SHOPPES AT TYSON PLACE

SUMMARY

<p>Owner Edgar Yates Colleen Yates, Clifton Ackerman & Joy Ackerman</p> <p>Applicant Javier Omana CPH, Inc.</p> <p>Project Planner Colandra Jones, AICP</p>	<p>Property Location: The subject property is located west of Narcoossee Road, north of Tavistock Lakes Boulevard, and south of Tyson Road (±14.63 acres, District 1).</p> <p>Applicant's Request: Specific Parcel Master Plan (SPMP) approval for 60,000 square feet of development comprised of retail, restaurants, bank and grocery store on 7 parcels within the Blackfin Shoppes PD.</p> <p>Staff's Recommendation: Approval subject to the conditions in the staff report.</p>	
<p>Updated: July 18, 2016</p>

TYPICAL REINFORCED WALL SECTION

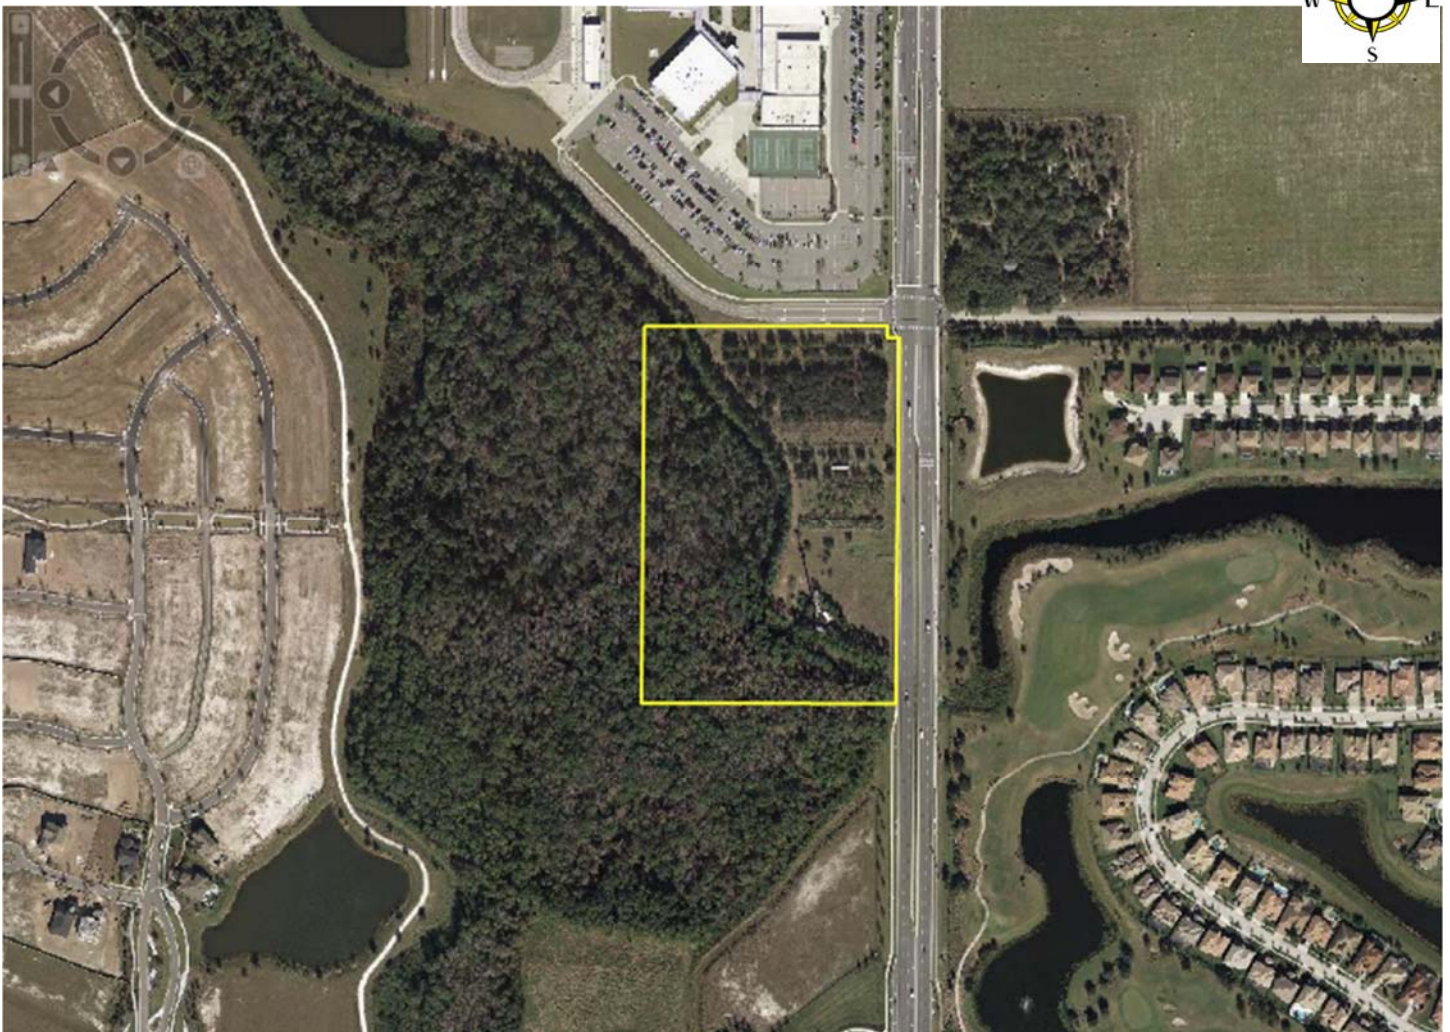
According to LDC Section 68.505, it requires a minimum 50 foot upland buffer for protected wetlands. The applicant is requesting an alternative standard from this requirement. The applicant is also requesting an alternative standard of this requirement. According to the site plan, it depicts a 25 foot setback from rear building of grocery store to wetland. One way the applicant is proposing to mitigate this standard is proposing a wall with a railing between the wetland boundary and the developable area. This wall section is depicted on the following page.

The Reinforced Wall Section shall be revised to show dimensions and proposed curb.

CONCEPTUAL LANDSCAPE PLAN

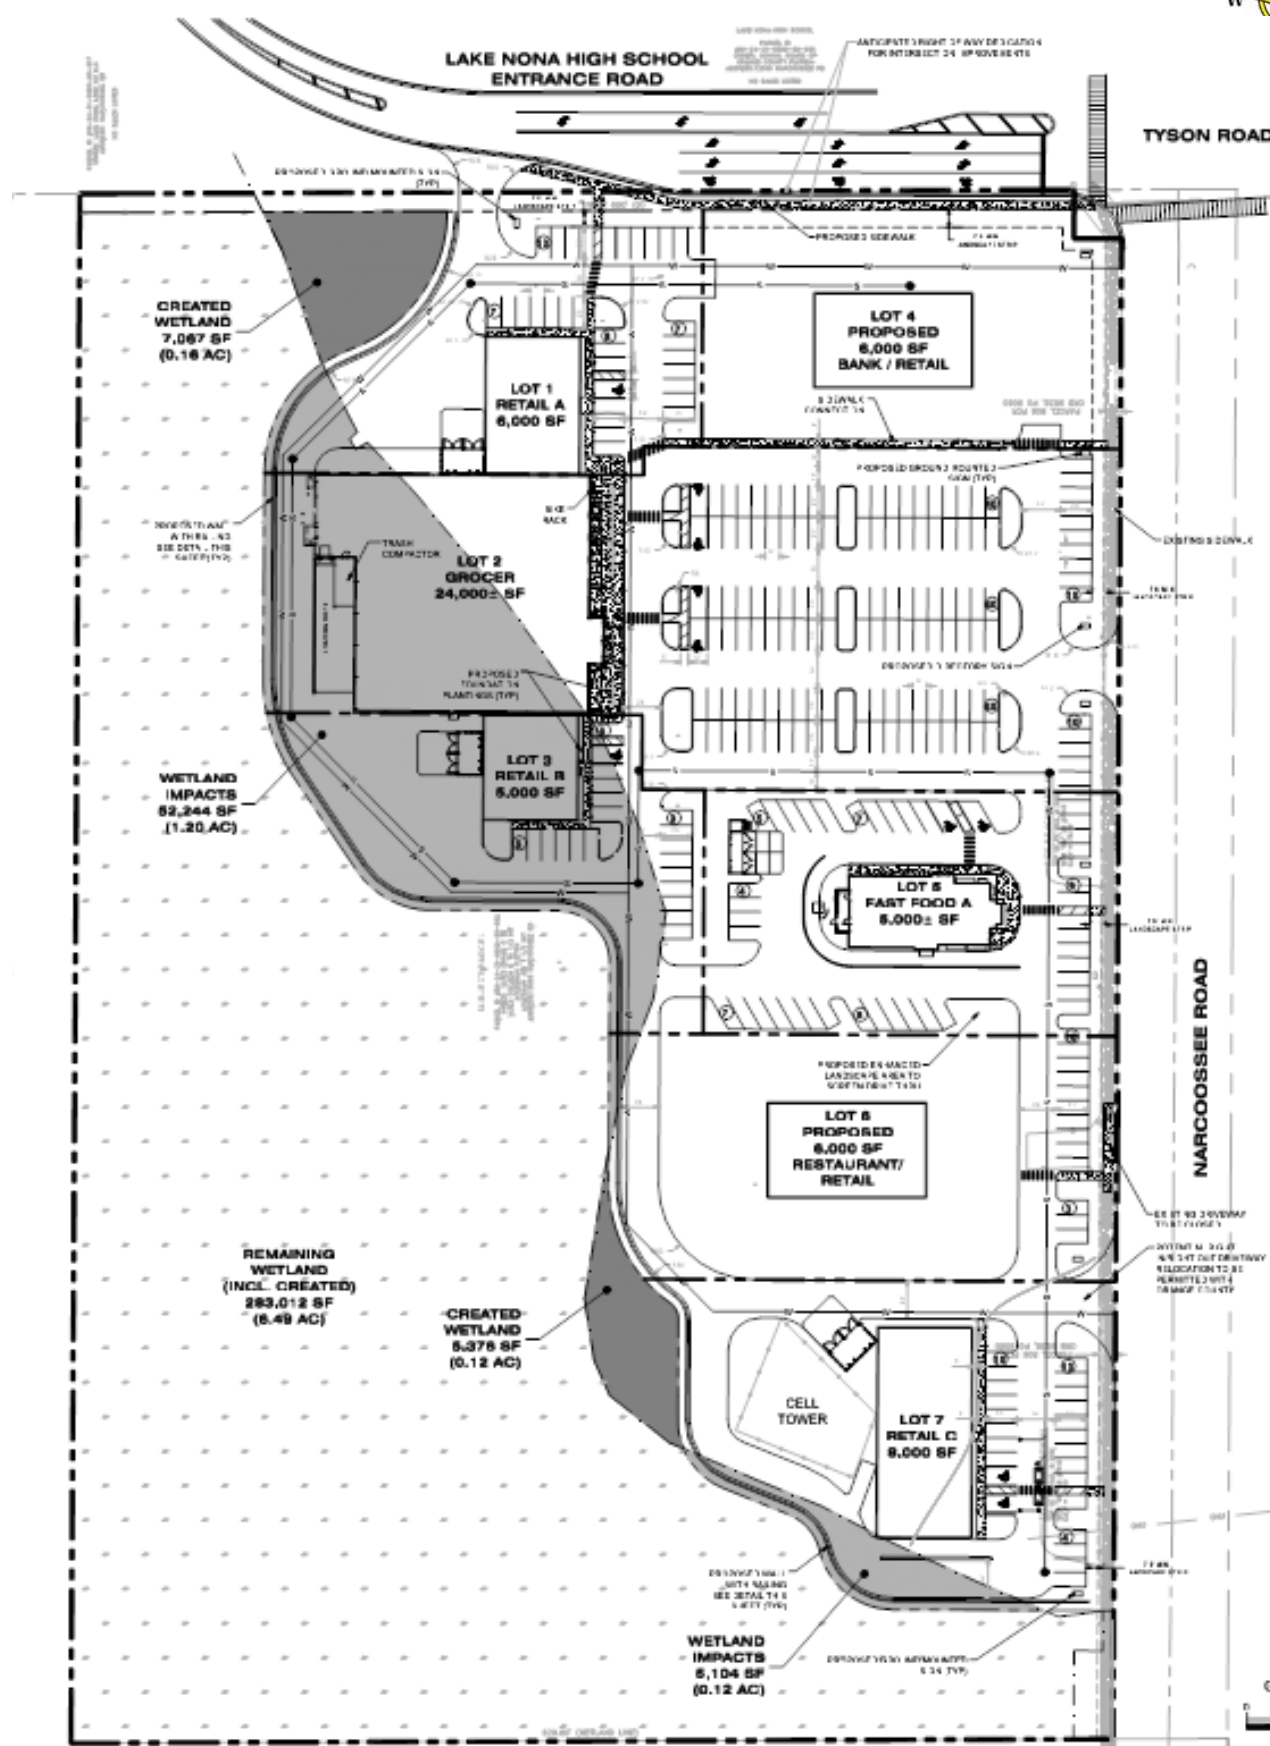
The applicant submitted a conceptual landscape plan with this application that is found on page 8 of this report. The final landscape plan will be developed in accordance with Chapter 60 of the LDC. A final landscape plan, including plant list, will be submitted for Appearance Review prior to building permits. Street trees are required on Narcoossee Road.

The landscaping plan shall be developed in accordance with LDC Chapter 60. A final landscape plan, including plant list, shall be submitted for Appearance Review prior to building permits. Include additional landscaping to make up for amount lost. This must be achieved by calculating tree points as depicted in LDC Chapter 60. A tree survey and tree removal permit is required.

According to LDC Section 61.312, the landscape area must be 7.5 feet adjacent to rights of way and property lines. This plan will allow an alternative standard to this requirement for the area adjacent to the wetland area against the retaining wall. The applicant shall provide additional interior landscaping to compensate for the lack of perimeter landscaping along the wetland area.

ARCHITECTURAL ELEVATIONS—LOT 2: GROCERY

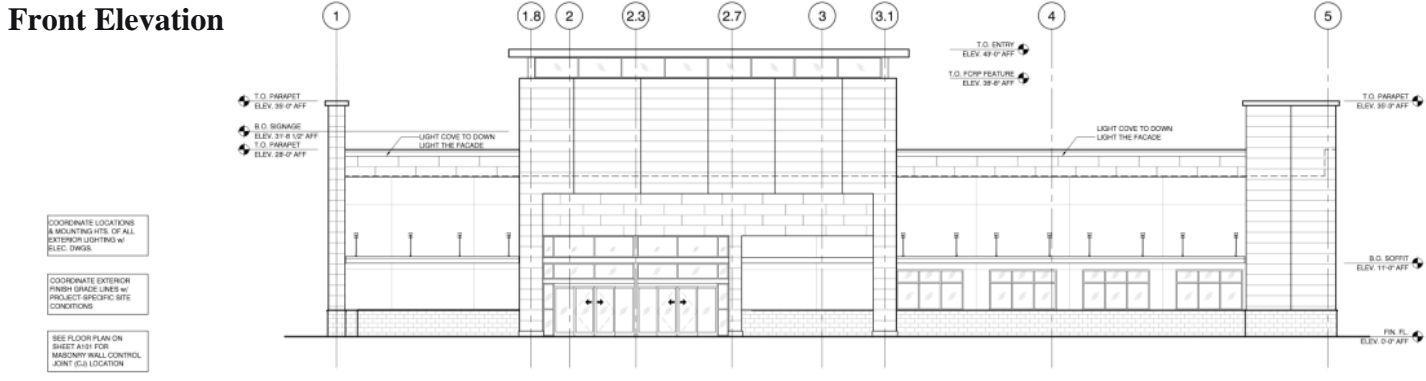
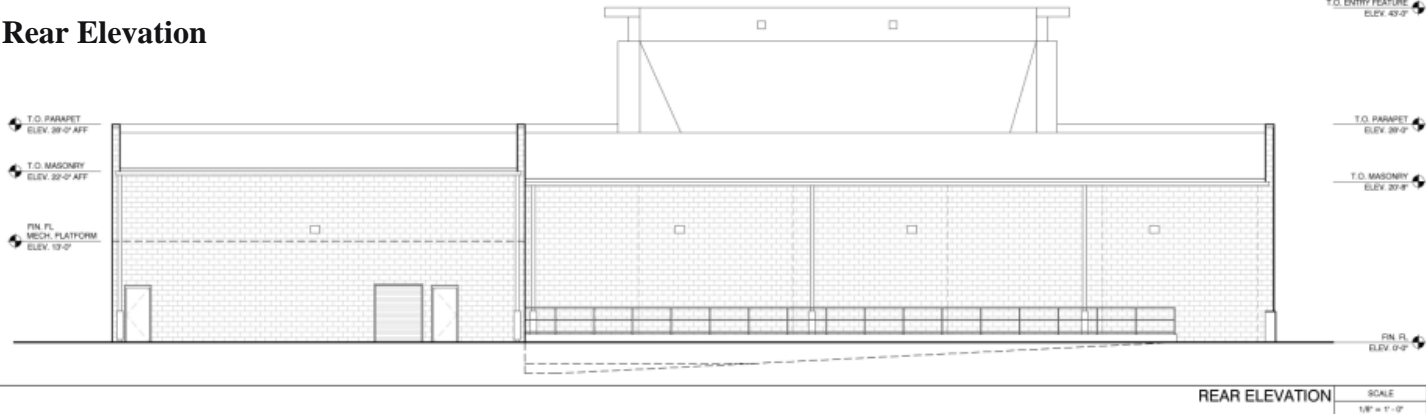
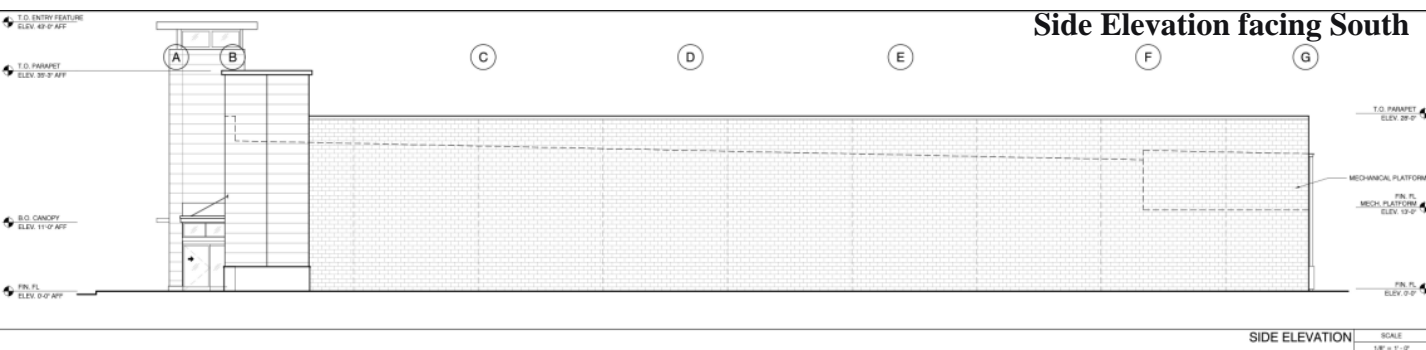
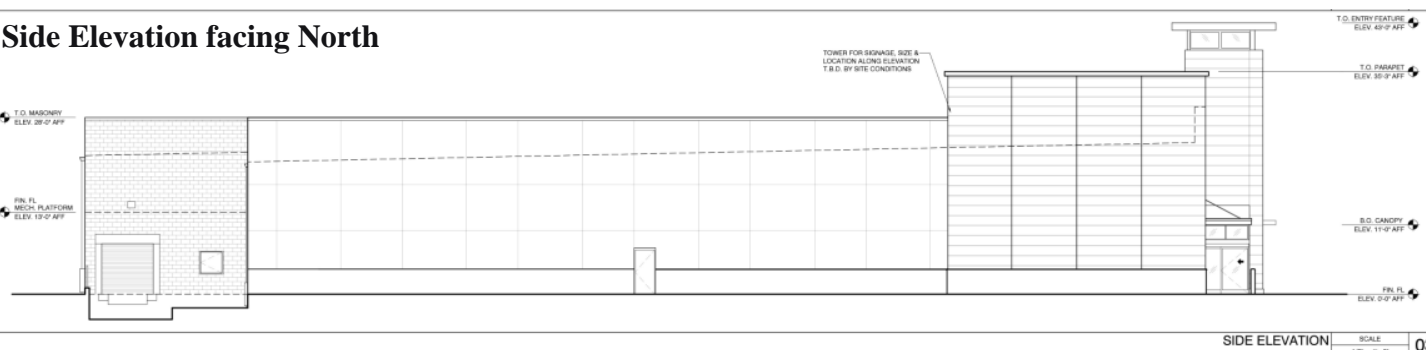
1. Appearance review is required prior to permitting for all buildings, via Planning Official determination. All buildings shall incorporate a durable base (non-stucco) material a minimum of 2-ft in height, the required transparency, a three dimensional treatment of the parapets (with a minimum 5-ft return). Architectural continuity between the buildings is required to be incorporated into each building, such that there are not random buildings that are unrelated to each other; this may include, but is now limited to: continuity of materials, similar base and parapet treatments, coordinated landscaping, etc. All other code requirement shall also be incorporated into the design at this required review (e.g. the current elevations provided for the store may not meet the required screening of all mechanical equipment on the roof, which is required to be screened horizontally).

2. Provide 30% window transparency toward Narcoossee Road, and 15% towards the driveway that leads to the high school (which was originally planned as a right of way) on all buildings.

7. Provide additional landscaping along the Lot 2 grocer's northern "sheer wall", with a minimum Bufferyard "A" plantings, as this elevation is exposed to the north.
